INITIAL FIRE SAFETY INSPECTION REPORT

Aptech Caswier Ltd (Extension)

RSC ID: 26600

Fire Safety Inspection Report

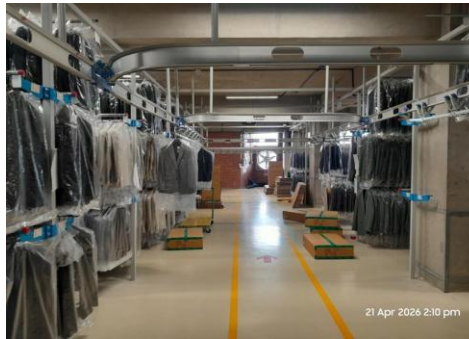
SI No.	Category	Findings	Required Action	Remediation Time Frame
F-01	Means of Egress	The exit stair enclosures are not separated from work areas and other spaces on each floor by fire-rated construction Location(s): Warehouse Building. Non-compliance: Fire doors are not properly functional on multiple floors.	The exit stair enclosure shall be provided with a minimum of 2-hr. fire resistance rating for buildings 4 or more stories. Provide 1.5 hr. fire rated door and seal all penetrations and openings by 2 hr. fire rated fire rated barrier construction for buildings with 4 or more stories in accordance with section 6.3.1.2 of RSC Technical Guidelines (Standard). Ensure that the fire doors are self-closing and positive latching and that they are provided with fire exit (panic) hardware where serving production floors. If fire doors are required to be held open for functional reasons, provide automatic closing devices tied to the fire alarm system. Keep proper datasheet & certifications for installed fire doors & accessories on-site for verification. The clearance under the bottom of a door shall be a maximum of 3/4 in. (19 mm).	Within 3 Months

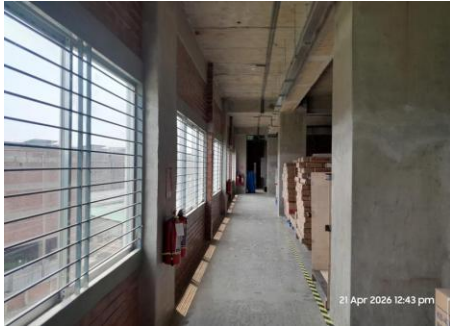
SI No.	Category	Findings	Required Action	Remediation Time Frame
F-28	Means of Egress	The exit stair enclosures are not separated from work areas and other spaces on each floor by fire-rated construction. Location(s): ACL Extension Building. Non-compliance: Penetration, Openings from the chemical store (Ground floor) are not provided as per BNBC Table 3.2.1.	The exit stair enclosure shall be provided with a minimum of 2-hr. fire resistance rating for buildings 4 or more stories. Provide 1.5 hr. fire rated door and seal all penetrations and openings by 2 hr. fire rated fire rated barrier construction for buildings with 4 or more stories in accordance with section 6.3.1.2 of RSC Technical Guidelines (Standard). Provide a fire-resistive rated assembly between the exterior exit stairs and the building up to 10 ft. beyond the end of the stair to achieve the required separation. The rated assembly shall be approved and/or designed by a qualified fire protection engineer. Ensure that the fire doors are self-closing and positive latching, and that they are provided with fire exit (panic) hardware where serving production floors. If fire doors are required to be held open for functional reasons, provide automatic closing devices tied to the fire alarm system. Keep proper datasheet & certifications for installed fire doors & accessories on-site for verification. The clearance under the bottom of a door shall be a maximum of 3/4 in. (19 mm).	Within 3 Months

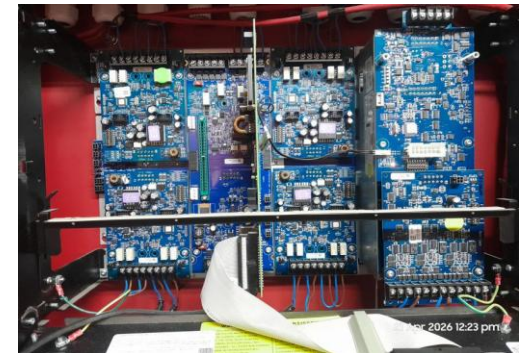
F-39	Means of Egress	The maximum travel distance exceeds 15m, (available: 25 m approx), which does not meet the requirements as per BNBC 2020, Table 4.3.8. Location: Ground Floor, Chemical Store (J2), ACL Extension Building.	Reconfigure the egress arrangement to reduce the maximum common path of travel to not more than 8 m. The common path of egress travel for Group J (high hazard) occupancies shall not exceed 8 m (25 ft). Section 6.13.2 of RSC Technical Guidelines (Standard) shall meet.	Within 3 Months
